***ADDENDUM # 002***

**St. Joseph Catholic School**  
**535 Birchbank Drive**  
**Corunna, Ontario**

**Office and Library Renovations**

**Project No. 634-CP1714-2**

**RELOCATION OF DEVICES FROM WALL TO BE DEMOLISHED**

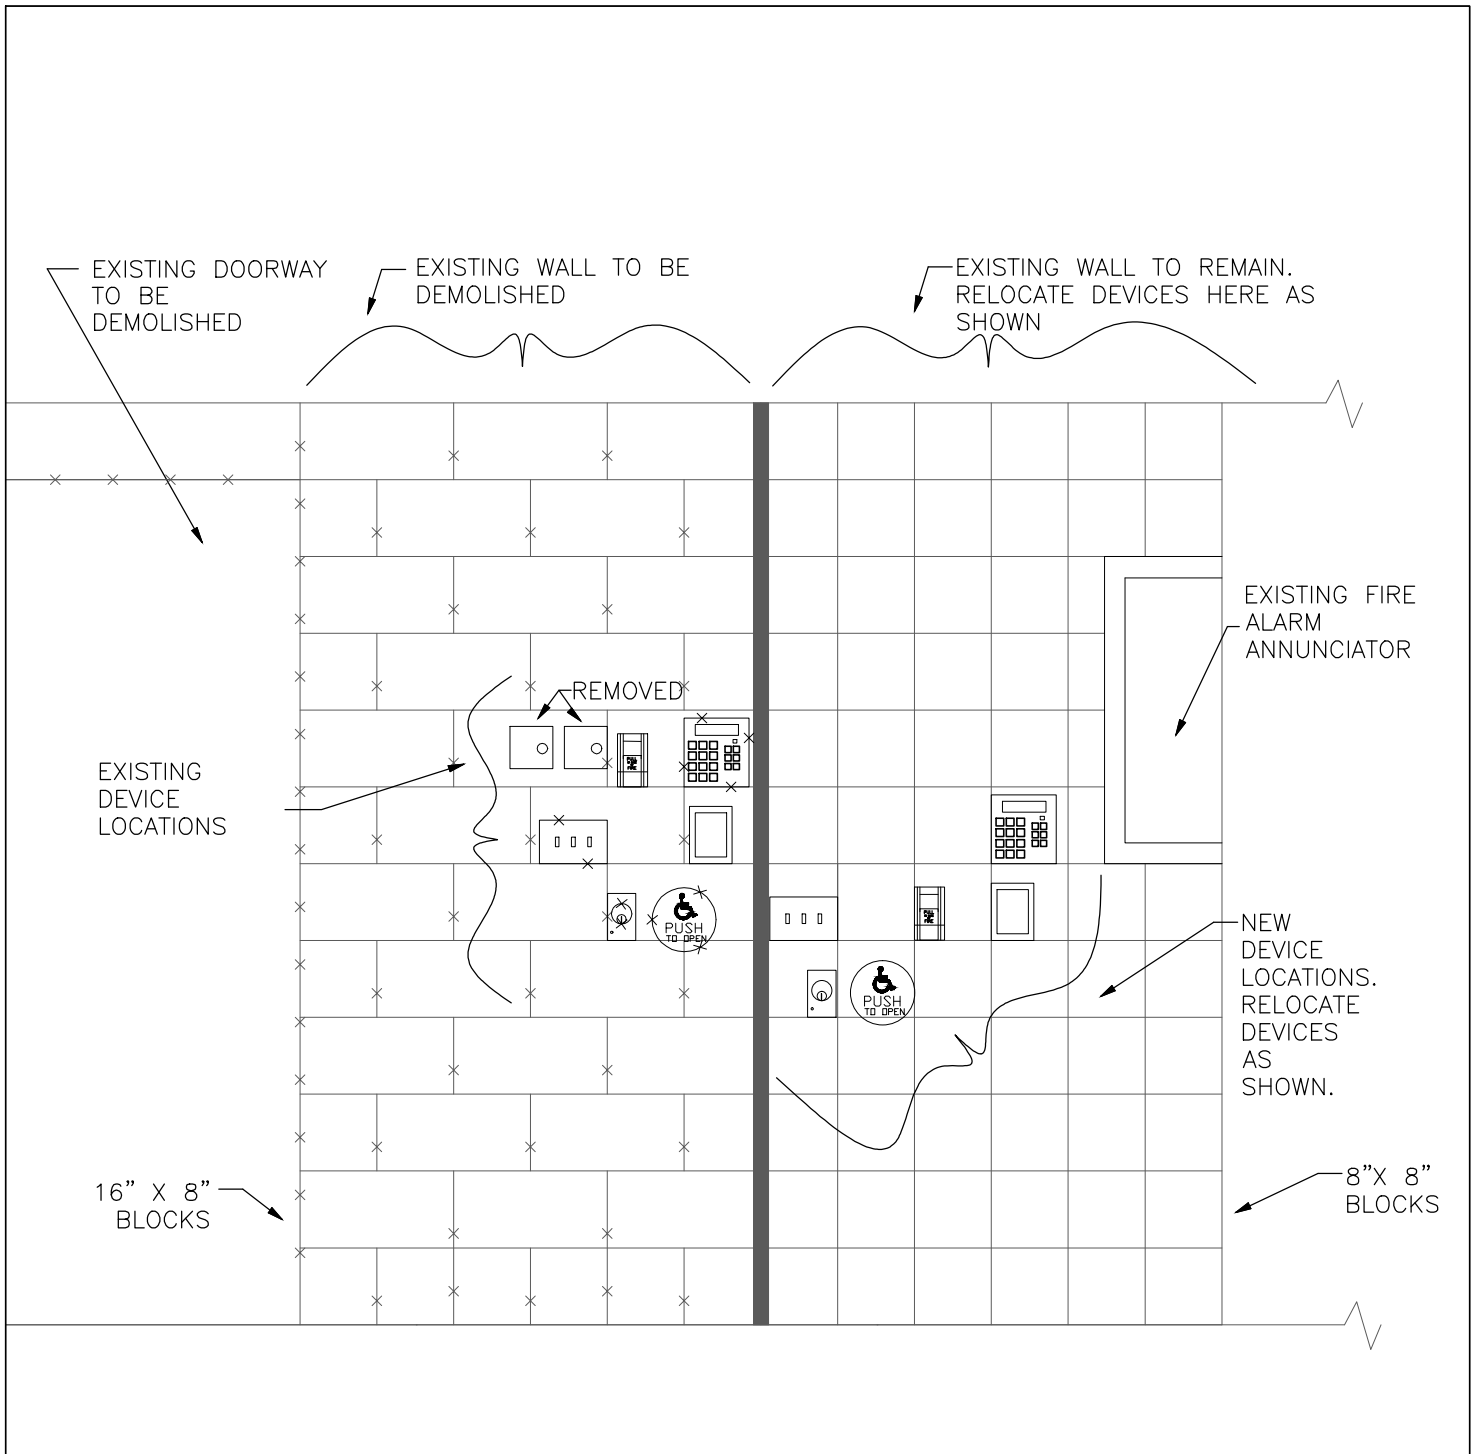
- 2.2. Drawing E2 of 5
  - 2.2.1. Administration Offices Renovation - A portion of the existing east wall of the existing administration office is being demolished to accommodate a larger glazing partition between the office and the corridor. Relocate the existing fire alarm pull station, the three gang switch box and switches, the back-box and push button for the barrier free door operator, the back box and key switch for the door lock activation and release, the security system key pad and the FOB proximity reader. Provide pull wires through the block walls from the device boxes to the accessible ceiling space above. Security System wiring and terminations, by Damar Security. Door control system terminations by JPW. Wiring for door controls by electrical trade.
